INITIAL REPORT 10CFR PART 21 REPORT OF A POTENTIAL SAFETY HAZARD

Date:	<u>July 19, 1995</u>
File No.:	<u>F-36674A/B/C/D</u>
Serial No.:	<u>T-36674A/B/C/D</u>
Type:	<u>GS2N</u>
Ref.:	<u>N/A</u>
Part No.:	<u>75233A06</u>
Dwg. No./	<u>75233A</u>
Rev. Level:	<u>D</u>

PREPARED BY: Richard Kling
 TITLE: Supv. N/N Prod. Eng.
 PART NAME: Nut-Lock-Flex Loc Reg. Height

FINAL REPORT 10CFR PART 21
REPORTING OF DEFECTS AND NON-COMPLIANCE

REGULAR NUT

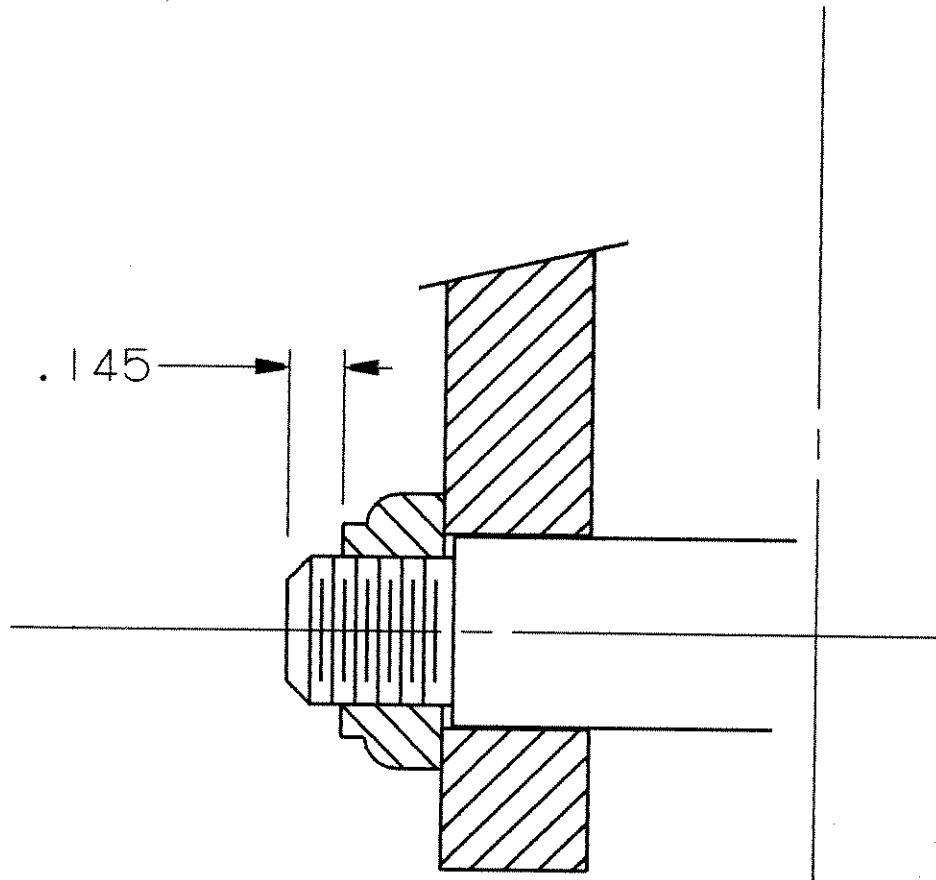
The possibility of the regular height flex loc nut part number
75233A06 not fully engaging the locking feature of threads.
See attachment #1

To provide 100% assurance that the locking portion of a nut would be fully engaged with threads of the mating linkage pin would require nut FLEXLOC (thin) DRESSER-RAND part number 75232A06 as shown on attachment #2. The regular series FLEXLOC nut does not provide full thread engagement of the locking feature, based on nominal part dimensions as shown on attachment # 1.

During a seismic event or adverse vibration condition the locking force could be questionable. With the thinner nut DRESSER-RAND part number 75232A06 would provide a better design because of the greater assurance of full locking feature engagement by meeting the design requirements for the above conditions.

1. This defect does constitute a safety hazard and requires that a report be prepared.
2. Review the Terry nuclear bill of materials that call out either of these nuts and evaluate the individual applications.
3. All nuclear customers should be made aware of this potential defect.

TYPICAL ASSEMBLY

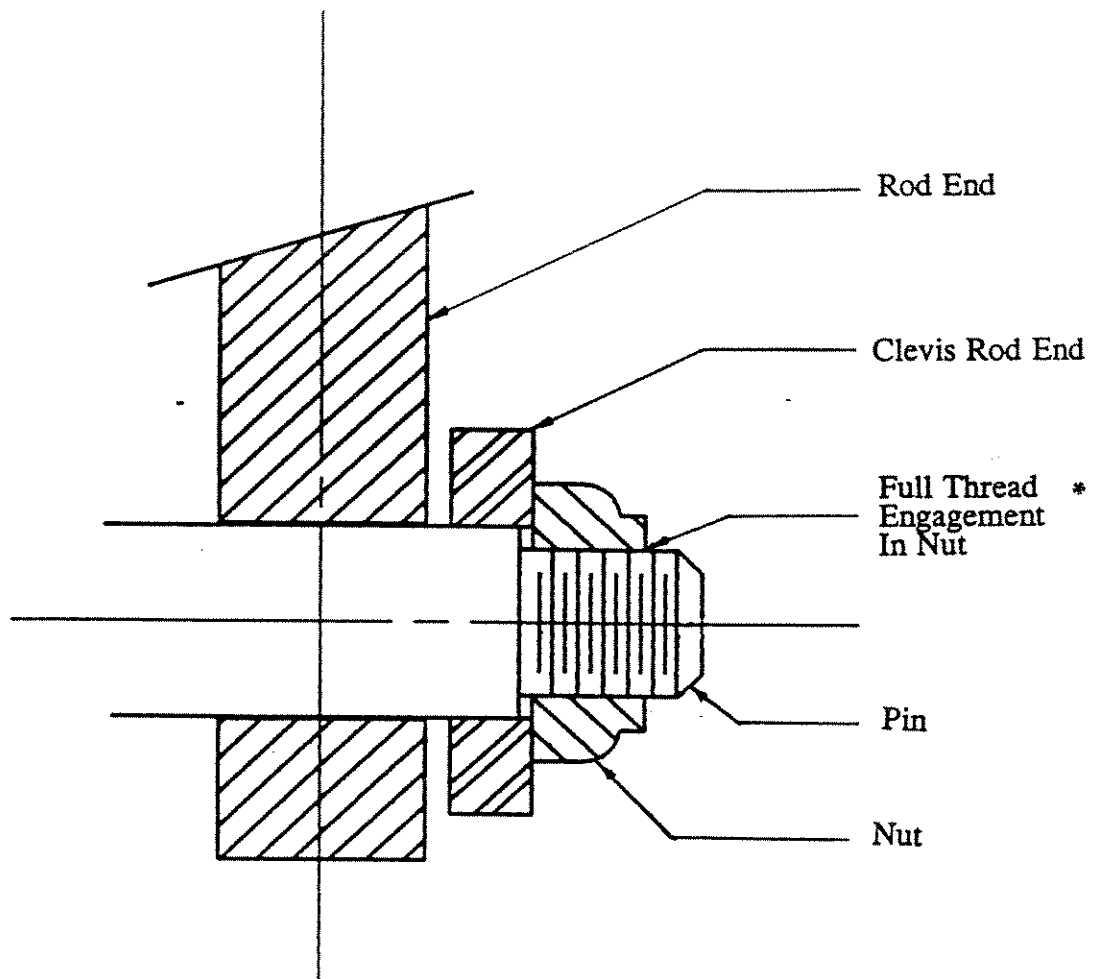
Regular locknut, SPS-Flexloc no. 21FA616, D-R p/n 75233A06 may be installed on governor valve linkages where the thinner locknut, SPS-Flexloc no. 21FK616, D-R p/n 75232A06 is required.

Inadequate thread engagement in the thicker locknut may result in linkage separation if the nut loosens from vibration and spins off. This will result in loss of turbine control capability.

Inspect all applications of locknuts on the control linkage for full thread engagement in locknut.

*** All threads in the locknut must be engaged by the threads on the pin. Amount of exposed threads will vary with application.**
